**Dogger Bank South Offshore  
Wind Farms**

**The Applicants' Responses to Deadline 8  
Documents**

**Document Reference: 19.2**

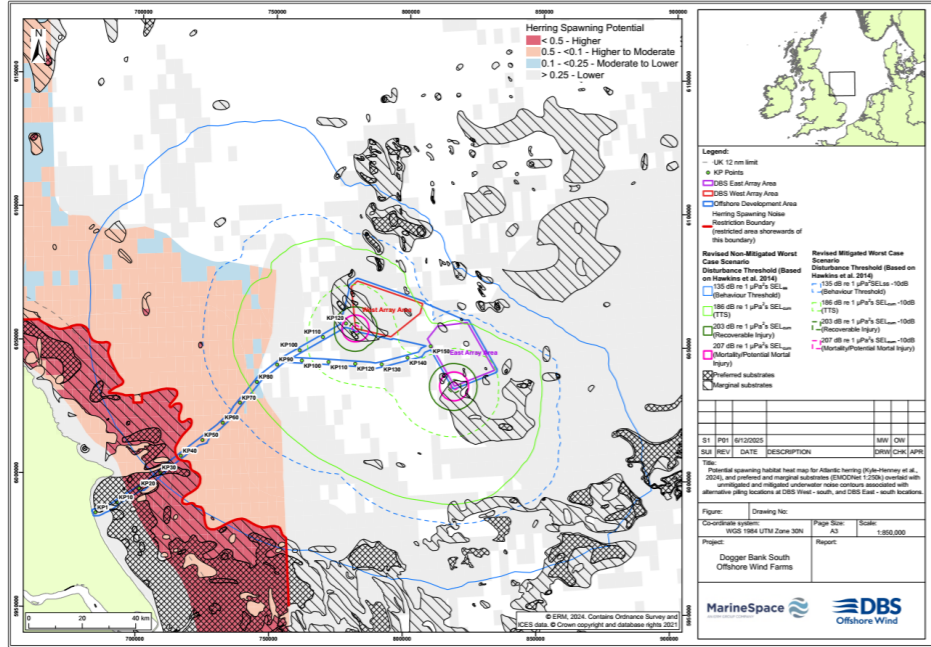
REP8-048: 4.6.2	Regarding the Applicant's statement, the annual herring larvae abundance maps presented in REP4-098, the Applicant's Fish and Shellfish Response did show data for herring larval presence at the IHLS sampling point which was located between KP 50 – 60 of the ECC. However, it should be noted that the IHLS survey collects herring larval data from fixed sampling stations at set locations across the survey grid, and the DBS OWFs ECC just so happens to overlap with some of these sampling stations (between KP 20-30 and KP 50-60). In the context of the larval abundance data point located between KP 50-60, I agree with the Applicant's statement, and this was outlined in my response to the Examining Authority's (ExA) Question 1.6 FSE.2.9 a) which is provided in Section 4.2 above. The MMO recognises that the PSA analyses for the ECC shows that	The MMO's response provides clarification that Atlantic herring larvae are present at locations that are not underpinned by potential spawning habitat, therefore the larvae must have been subject to transport by currents. In the case of the IHLS station between KP50 and KP60, the nearest potential spawning habitat is >5 km to the west. Therefore, in a matter of days post-hatching, Atlantic herring larvae may be transported significant distances from their hatching location.

Figure 2. UWN modelling in relation to sandeel habitat and spawning ground and UWN modelling (RWE, November 2024).

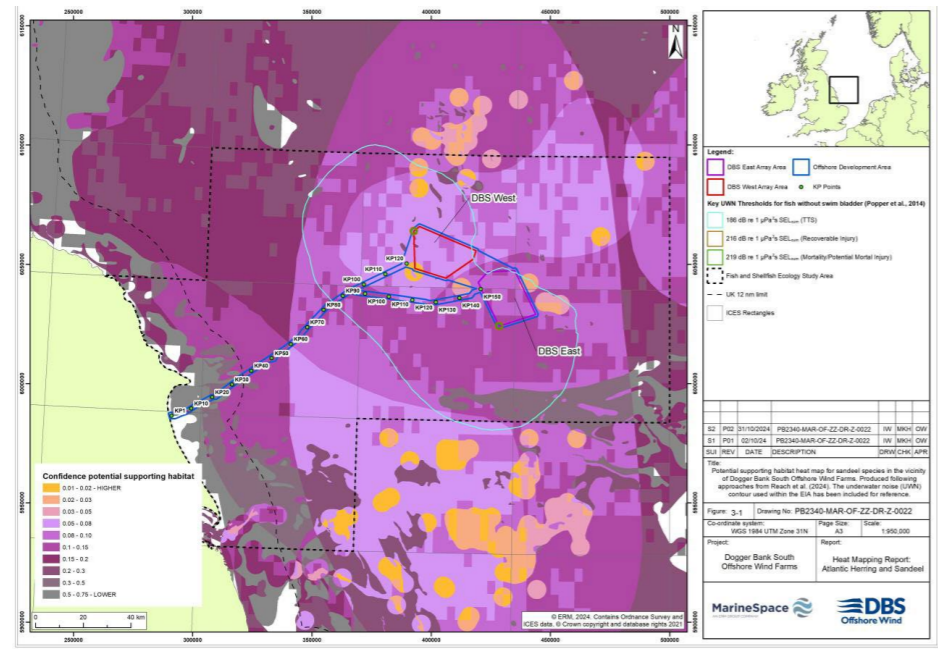
<p>REP8-048: 4.8.6</p>	<p>The UWN modelling presented in the Applicant's Heat Mapping Report: Atlantic Herring and Sandeel (RWE Nov 2024) shows the noise contours for the range of effect for mortality and potential mortal injury, recoverable injury and TTS in sandeel (see Figure 2). As can be seen from Figure 2, the ranges of effect for mortality and potential mortal injury, recoverable injury are small in the context of the wider available habitat. However, it should be recognised that the UWN modelling represents one modelled pile in each array area, whereas in reality, these impact ranges will occur at all sites where piling of foundations takes place, across each array. The heat map of sandeel habitat suitability in Figure 2 indicates that pockets of the array areas have 'very high' levels of confidence as sandeel habitat (denoted by orange colours), with the wider area being 'high' and 'medium' confidence as sandeel habitat. The impact range for TTS encompasses</p>	<p>The Applicants are in agreement that piling impacts will occur at each piling location, rather than at just those locations where modelling has been undertaken. It should be clarified that Figure 2 referenced in this comment related to Figure 3.1 of the <b>Heat Mapping Report: Atlantic Herring and Sandeel</b> [AS-105].</p> <p>The modelling undertaken to date represents the greatest area of potential impact associated with any two piles being installed simultaneously.</p> <p>It should be noted that the use of 'very high', 'high', 'medium', and 'low' potential categories is not relevant to the assessment of potential supporting habitat for sandeel, as numerical values should be used in reference to potential supporting habitat using the Reach et al. (2024) methodology. The impact range for TTS in Figure 2 (Figure 3.1 of the <b>Heat Mapping Report: Atlantic Herring and Sandeel</b> [AS-105]) therefore overlaps with the full range of lower to</p>

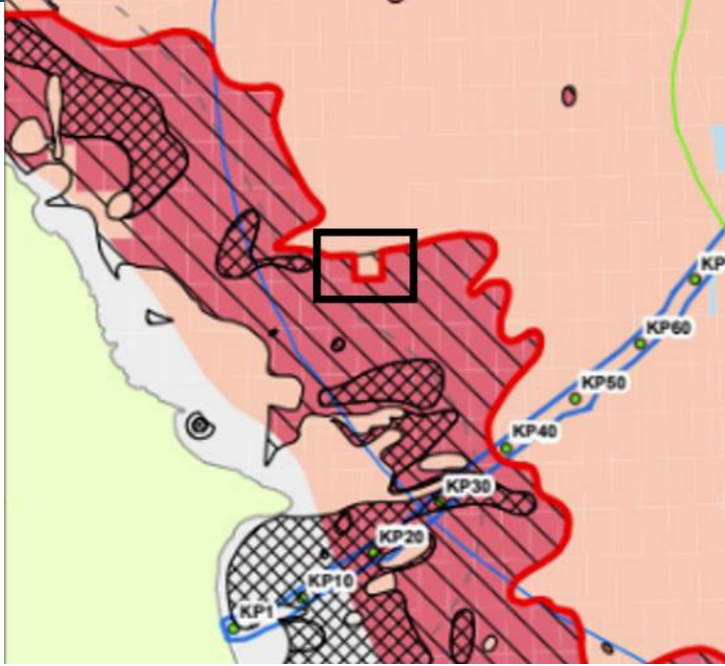
I.D.	Natural England's Response	Applicants' Response
	<div><p><b>Figure 1:</b> Section of Figure 17.8 taken from the Applicant's Herring Spawning Plan [REP7-135]. The black rectangle has been added by Natural England to highlight where the restriction boundary (red line) does not align with the underlying substrate boundary (black line).</p></div>
